UNITED STATES
DEPARTMENT OF THE INTERIOR
BUREAU OF LAND MANAGEMENT

SUNDRY NOTICES AND REPORTS ON WELLS
Do not use this form for proposals to drill or to re-enter an abandoned well. Use form 3160-3 (APD) for such proposals.

8. Well Name and No.
SJU TR-F 22

Legacy Reserves intends to temporarily abandon (TA) the subject well.

PROPOSED TA

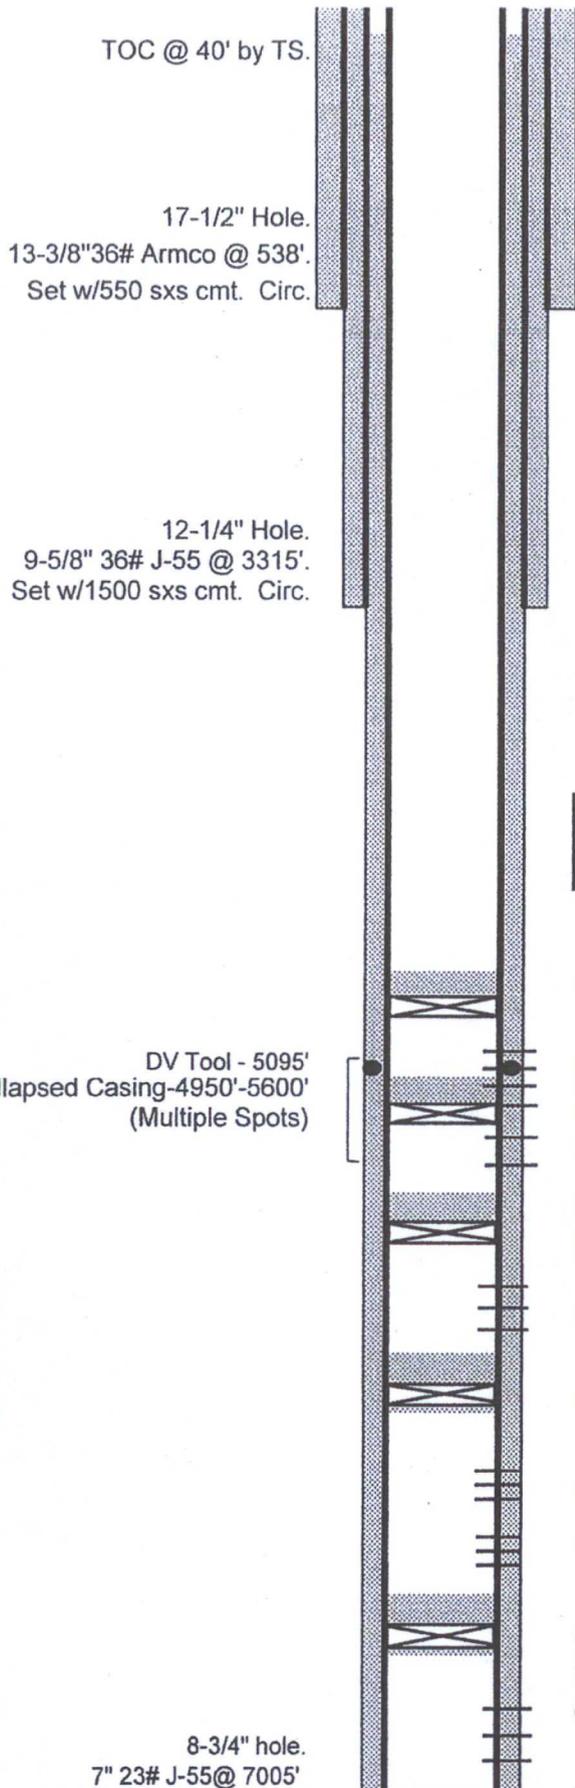
We plan on setting a wireline-set CIBP at 4920', 53' above the top perforation at 4973' and dumping

a 50' (9 sxs)cement cap on top using a wireline dump bailer. We will perform a MIT pressure test on the casing above the CIBP at 500# for 30 minutes and circulate the casing with packer fluid.

1. Well is approved to be TA/SI for a period of 12 months or until 02/16/2017
2. This will be the last TA approval for this well.
3. Must submit NOI to recomplete or NOI to P&A. Must be submitted by 02/16/2017
4. COA's met at this time.
